Well Name: JAMES RANCH UNIT DI 7 SAWTOOTH	Well Location: T23S / R31E / SEC 6 / LOT 4 / 32.340053 / -103.822345	County or Parish/State: EDDY / NM
Well Number: 702H	Type of Well: OIL WELL	Allottee or Tribe Name:
Lease Number: NMNM02887D	Unit or CA Name: JAMES RANCH UNIT	Unit or CA Number: NMNM70965X
US Well Number: 3001554879	Operator: XTO PERMIAN OPERATING LLC

Notice of Intent

Type of Submission: Notice of Intent Type of Action: APD Change

Procedure Description: XTO Permian Operating, LLC. respectfully requests approval to make changes to the approved APD. These changes will be SHL, FTP, LTP, BHL and casing and cement program will be updated. The proposed total depth of 22368' MD; 9827' TVD will remain the same as well as formation and pool – Los Medanos; Bone Spring. FROM: TO: SHL: 260' FNL & 1009' FWL of Section 6-T23S-R31E 260' FNL & 1129' FWL of Section 6-T23S-R31E FTP: 700' FSL & 900' FWL of Section 31-T22S-R31E 330' FNL & 1650' FWL of Section 6-T23S-R31E PPP-1-2: 2637' FNL & 990' FWL of Section 6-T23S-R31E 2636' FNL & 1650' FWL of Section 6-T23S-R31E PPP 1-3: 0' FNL & 990' FWL of Section 7-T23S-R31E 0' FNL & 1650' FWL of Section 7-T23S-R31E LTP: 2532' FNL & 990' FWL of Sect

WELL LOCATION AND ACREAGE DEDICATION PLAT

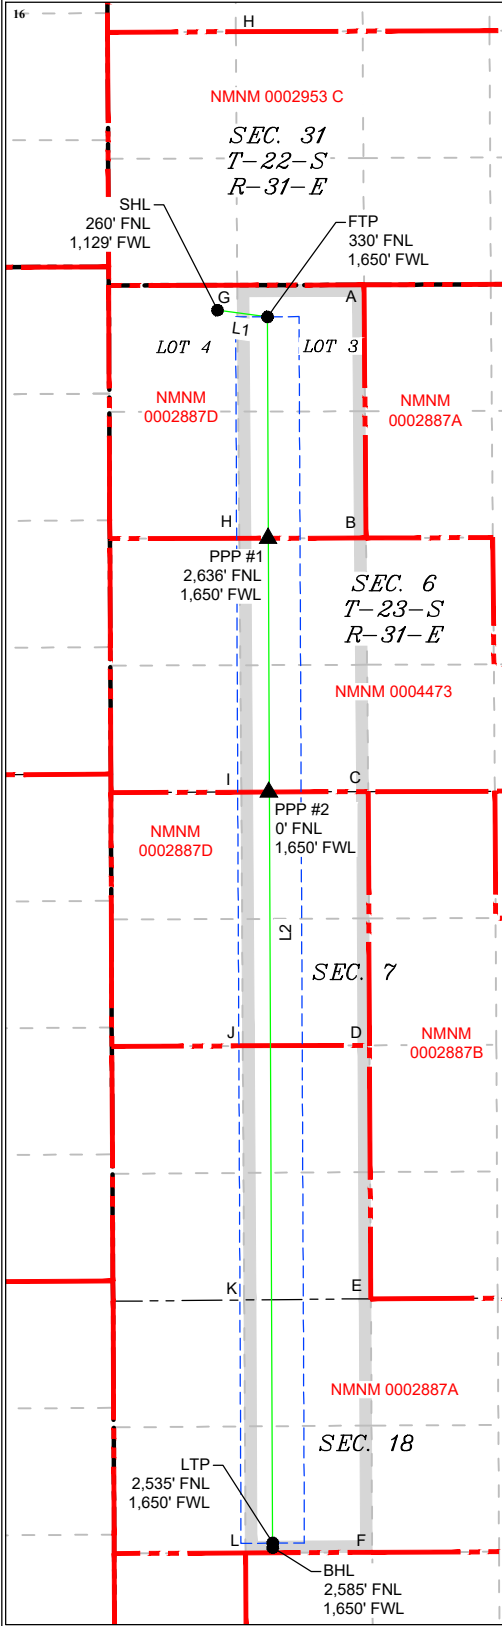
0. SHL: LOT 4 / 260 FNL / 1009 FWL / TWSP: 23S / RANGE: 31E / SECTION: 6 / LAT: 32.340053 / LONG: -103.822345 (TVD: 0 feet, MD: 0 feet)

BHL: LOT 2 / 2582 FNL / 990 FWL / TWSP: 23S / RANGE: 31E / SECTION: 18 / LAT: 32.304613 / LONG: -103.822425 (TVD: 9827 feet, MD: 22368 feet)
